### **Amendments to the Drawings**

## **REMARKS**

FIG. 1a (PRIOR ART)

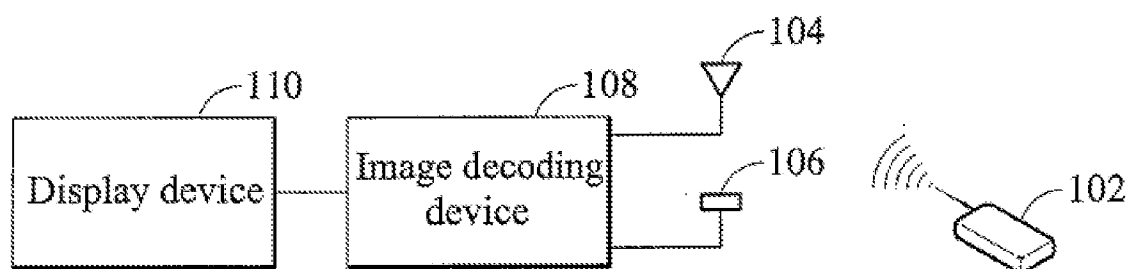
The drawings are objected to. First, the Office Action indicated that FIGs 1a and 1b should be amended to add the designation of “Prior Art” to the legend. Applicant has amended these figures accordingly. Second, the Office Action stated that the “transmitting system 300” is not labeled in Figures 3, 5, and 7. This objection is rendered moot by amendments made to the specification. Numbering and component designation is now consistent between the specification and drawings.

In Figs. 1a and 1b, the designation of “Prior Art” has been added to the figure legends.
